Access Compliance Report

Public Rights-of-Way

(Curb Ramps)

Intersection ID: 44701	Main Street: MARY_BLAIR_LN	Cross Street: EAGLES_LANDING_DR	Location: SE
ADA ID: 483EA6E65494	Ramp Type: Perp	Initial Pass/Fail: Fail	Overall Compliance: No
Severity Score: 21.25			
Codes/Mitigation Info/Possible Solution		Field Measurements/Component Compliance

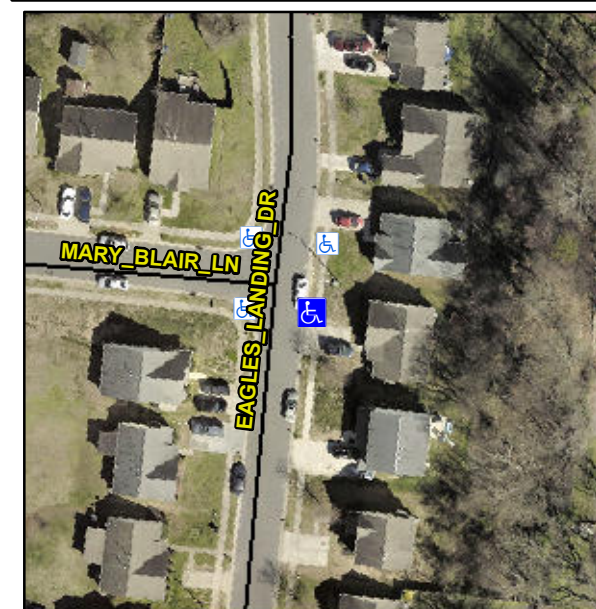
Not Found, R304.5.1, R304.5.3

Compliance	Description	Data	Compliance	Description	Data
N/A	Ramp Length (in)	48.0	Yes	Ramp Slope (%)	5.8
No	Ramp Width (in)	46.0	No	Ramp XSlope (%)	6.3
N/A	Flare Type LT	N/A	N/A	Flare Type RT	N/A
N/A	Flare Slope LT (%)	N/A	N/A	Flare Slope RT (%)	N/A
N/A	Flare Traversable LT?	N/A	N/A	Flare Traversable RT?	N/A
N/A	Landing Length (in)	N/A	N/A	DWS Provided?	N/A
N/A	Landing Width (in)	N/A	N/A	DWS Contrast?	N/A
N/A	Landing Slope (%)	N/A	N/A	DWS Length (in)	N/A
N/A	Landing X Slope (%)	N/A	N/A	DWS Full Width?	N/A
N/A	Landing Curb? (Y/N)	N/A	N/A	DWS Offset (in)	N/A
N/A	Shared Landing?	N/A			
N/A	Gutter Ponding?	N/A	N/A	Gutter Slope (%)	N/A
N/A	Gutter Lip Ht (in)	N/A	N/A	Gutter X Slope (%)	N/A
N/A	Painted X Walk1?	No	N/A	Painted X Walk2?	N/A
	X Walk 1 Direction	To W		X Walk 2 Direction	N/A
N/A	X Walk 1 Width (in)	N/A	N/A	X Walk 2 Width (in)	N/A
	X Walk 1 Slope (%)	4.2		X Walk 2 Slope (%)	N/A
	X Walk 1 X Slope (%)	5.1		X Walk 2 X Slope (%)	N/A

Remove & Replace Entire Ramp.
